Meetinghouse Farm Barn

Town of Barnstable
ADA Transition Plan

September 2021

Institute for Human Centered Design

Figure 1: Illustrating recommended clear floor space at a bench.

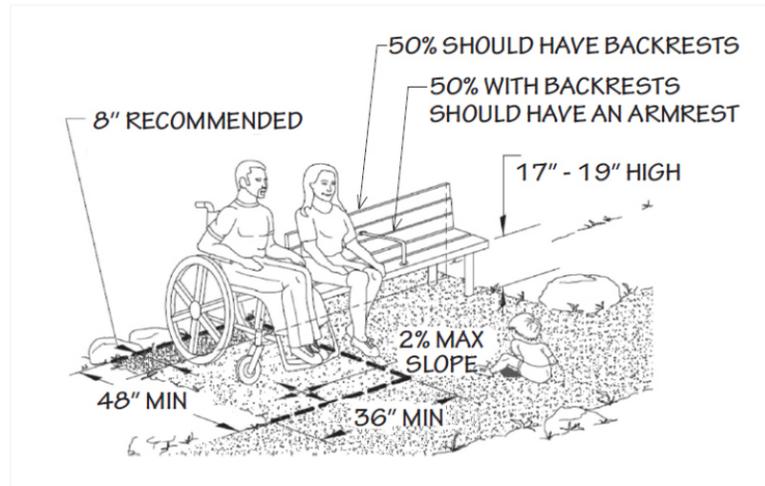
- Recommend providing a 36" by 48" firm, stable and slip-resistant area alongside the bench by the entry to the Rhododendron Forrest so that a person using a wheelchair or other mobility device is able to sit alongside someone seated on the bench with her/his shoulders aligned. See the diagram below for best practice recommendations for benches:

Figure 2: Illustration of one way to mark accessible parking spaces at unpaved parking areas.

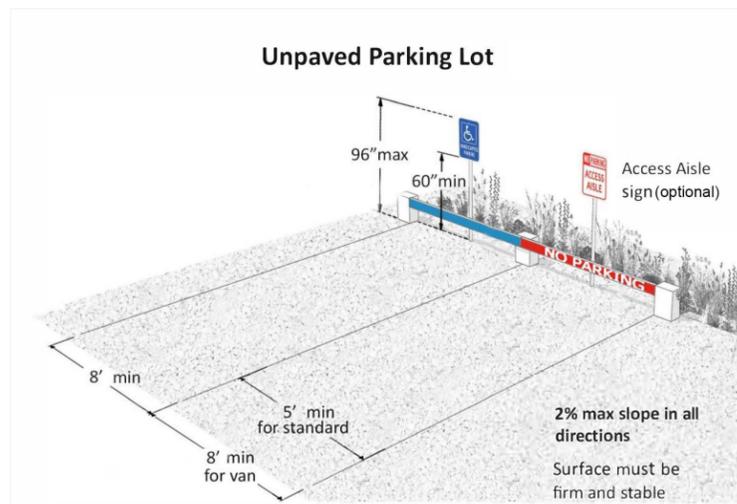
Accessibility issues include lack of a van accessible parking space. (See Figure 2 for an example of an unpaved accessible parking space.)

Note: If there are areas where members of the public are allowed to park, an accessible parking space is required.
